PROJECT: Stockton CA Parking Garage
JOB NO: 1282
DRAWING NUMBER: D-12a

CUSTOMER TURNER CONST
 PROJECT ESSENTIAL SERVICES BLDG
 LOCATION STOCKTON, CA

ANCHOR BOLT LAYOUT GARAGE STAIRS

COFAB STEEL CORP. VALLEJO, CA	
CUSTOMER	TURNER CONST
PROJECT	PARKING GARAGE
LOCATION	STUCKTON, CA
LAYOUT GARAGE STAIRS	
DRAWN BY	HL
CHECKED BY	
APPROVED BY	
DATE	3-16-00
JOB NO	905 E7
DRAWING	
REV

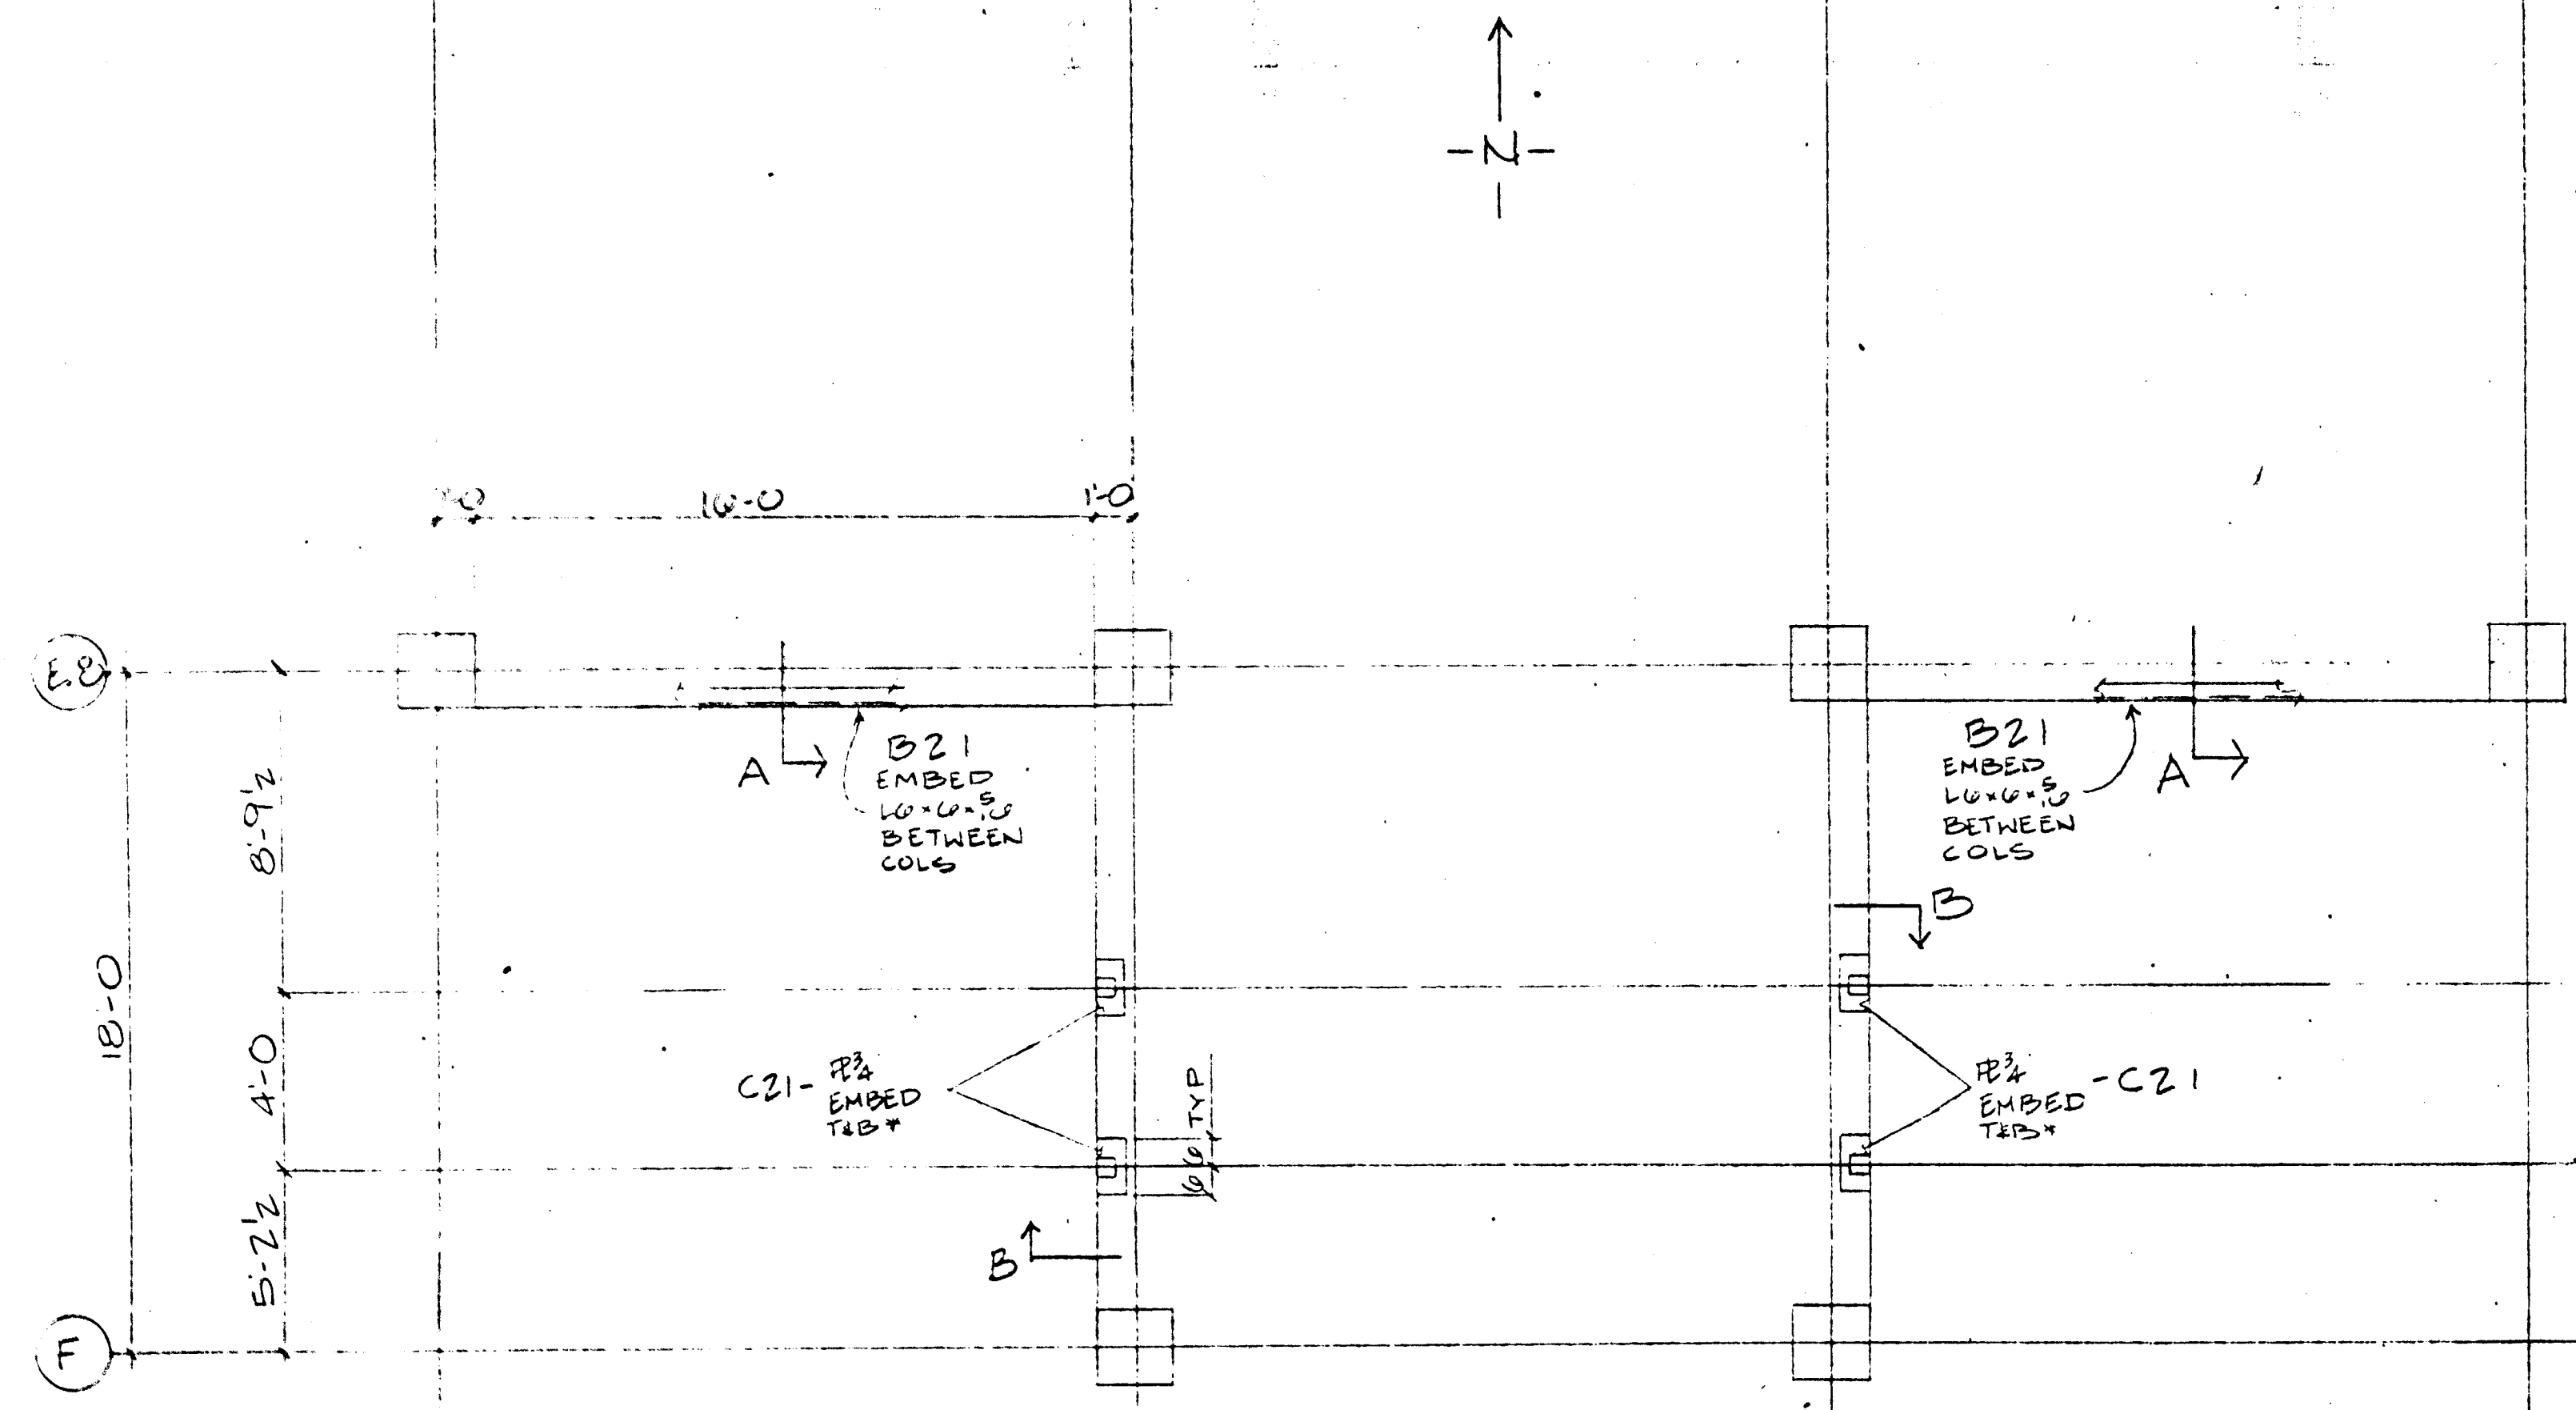
* TOP EMBED NOT REQ'D @ 8TH FLR. BOTT EMBED NOT REQ'D @ 2ND FLR

EMBED @ TOP OF CURB NOT TOP OF BM PER RAT 5/4/00
 TOP EMBED NOT REQ'D @ 8TH FLR
 REVISE COLNUS

BOTT EMBED NOT REQ'D @ 2ND FLR

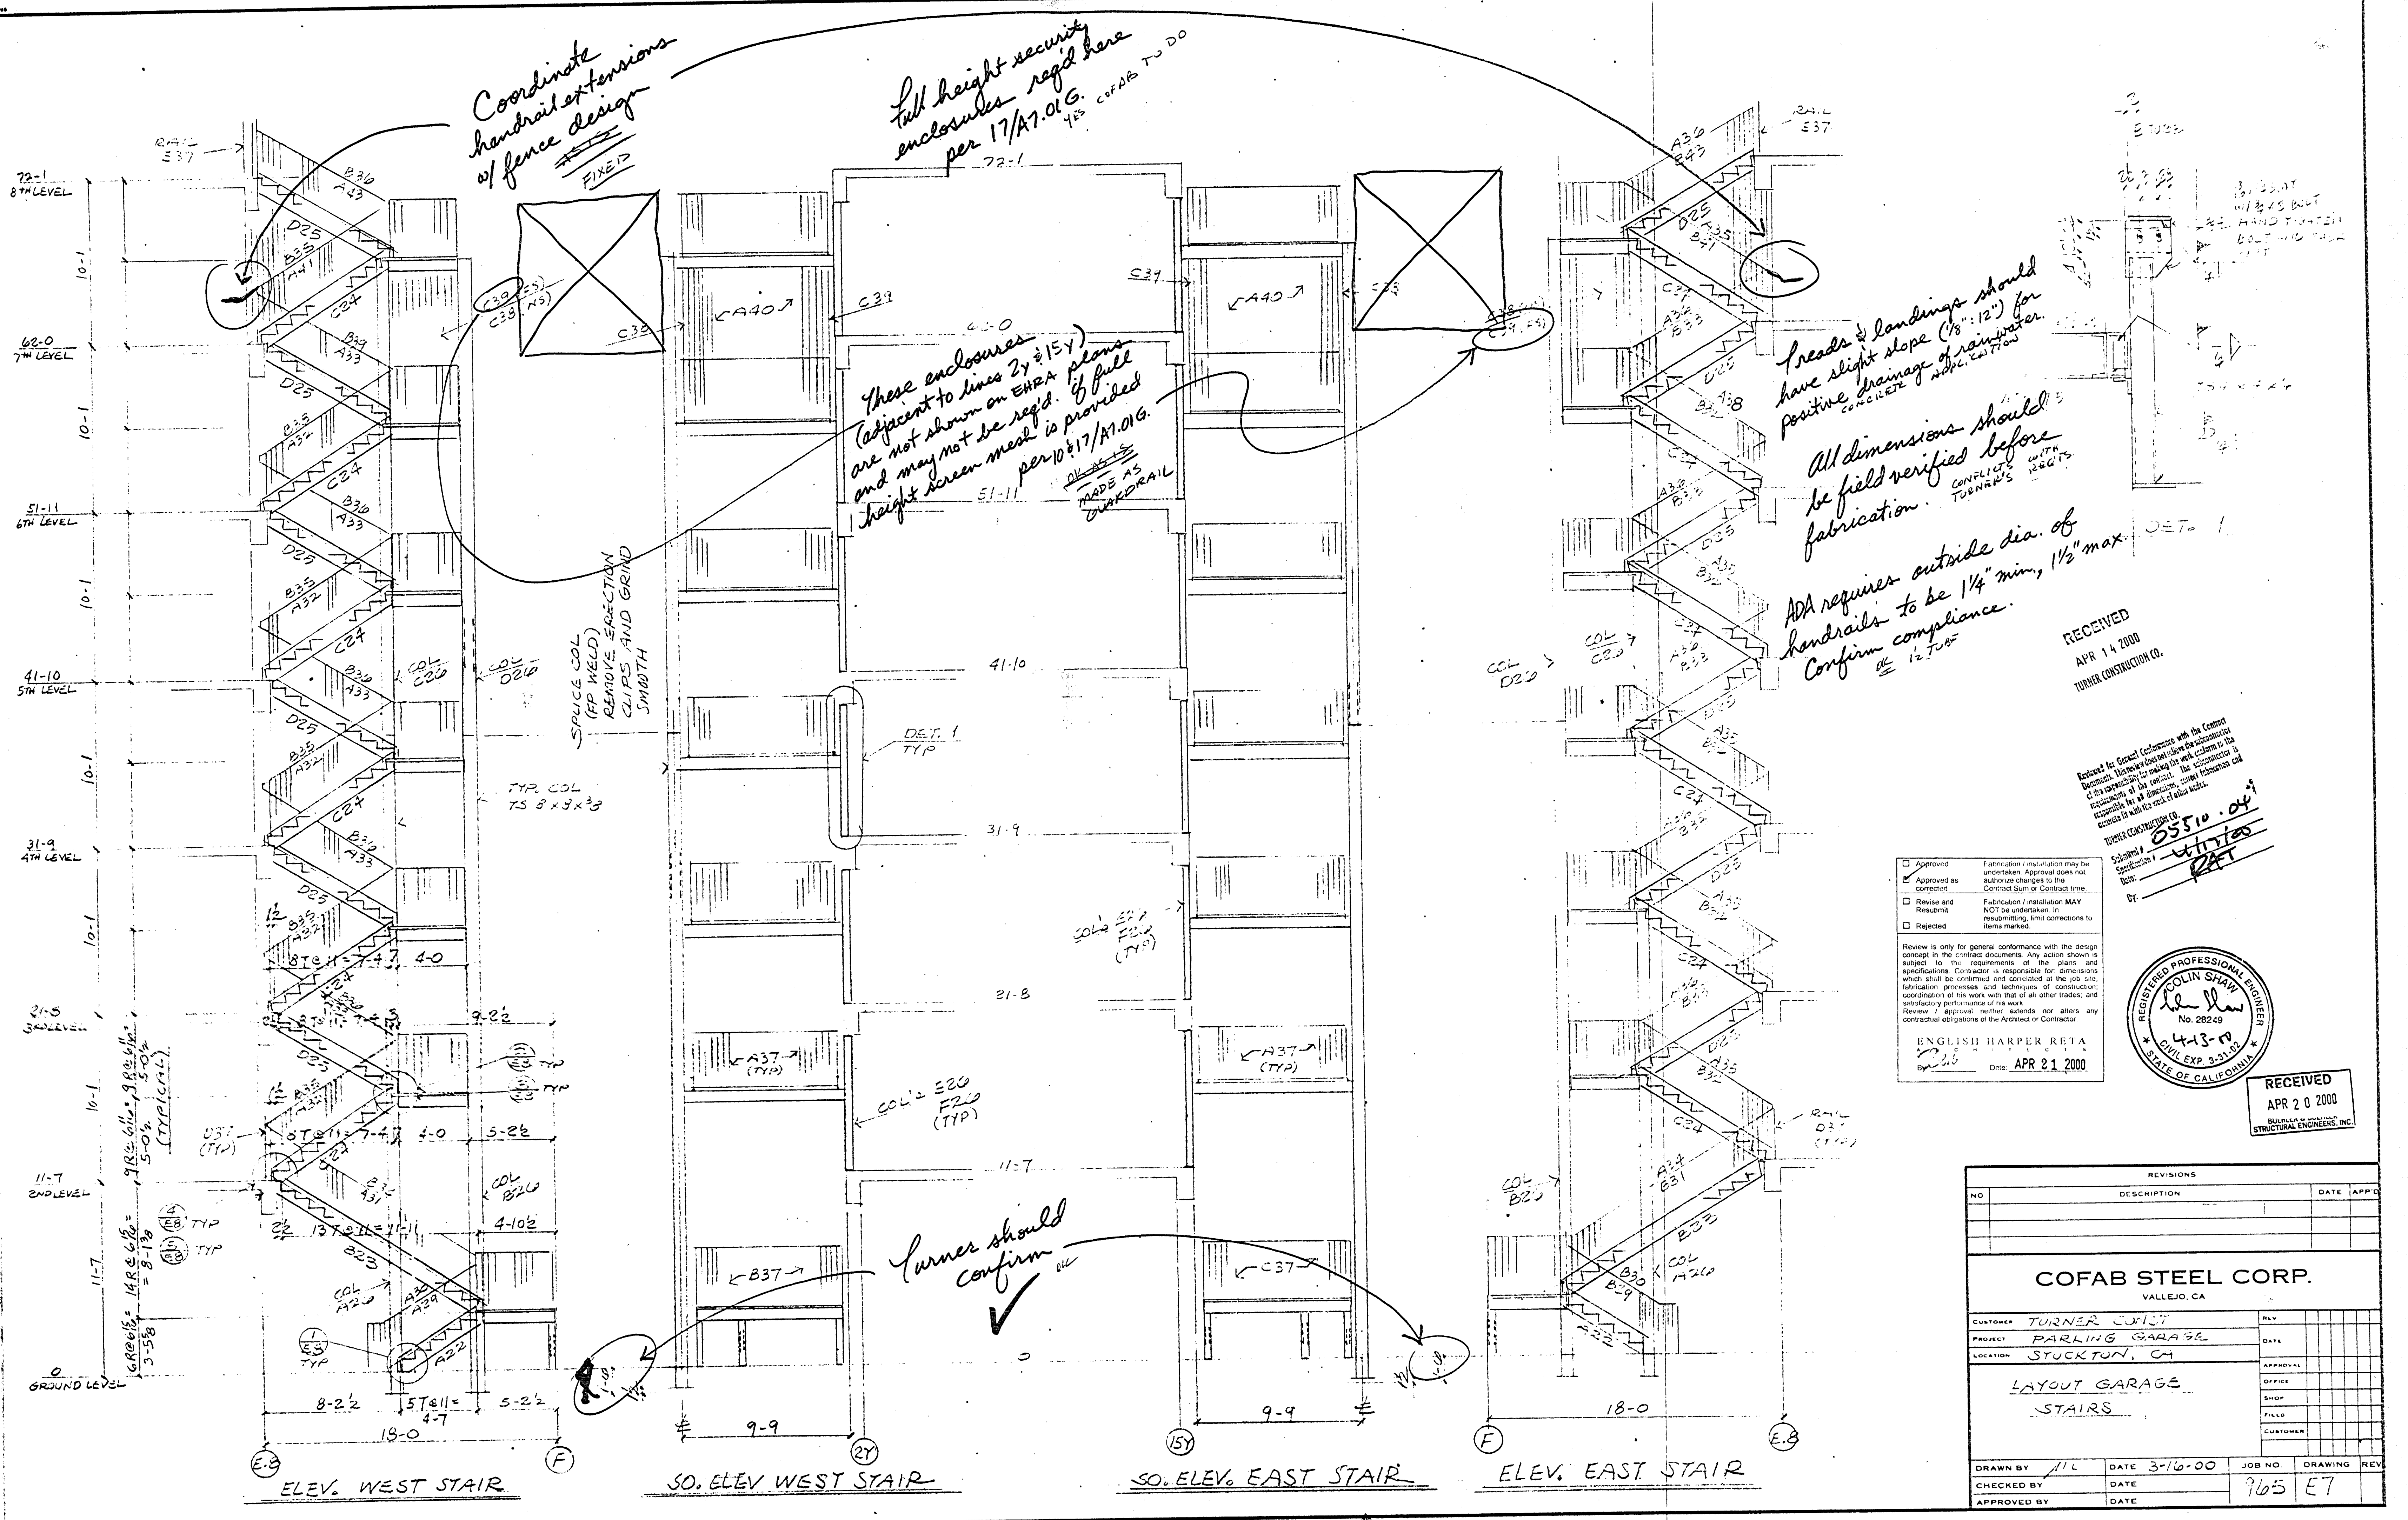
See sheet EB for comments
 Architect verify stair dimensions & handrail type

~~REVISE & RESUBMIT~~
 STAIRS ARE REQUIRED TO BE STEEL STAIRS / SHELLER PLATE TYPE

Coordinate handrail extensions of fence design
 FIXED

full height security enclosures req'd here per 17/A7.01.G.
 YES COFAB TO DO

These enclosures adjacent to lines 2y & 15y are not shown on EHPA plans and may not be req'd. If full height screen mesh is provided per 10 & 17/A7.01.G.
 MADE AS HANDRAIL

reads of landings should have slight slope (1/8" : 12") for positive drainage of rainwater.
 CONCRETE

All dimensions should be field verified before fabrication.
 CONFLICT WITH TURNER'S RIGHTS

ADA requires outside dia. of handrails to be 1 1/4" min., 1 1/2" max.
 Confirm compliance.
 12 JUL 05
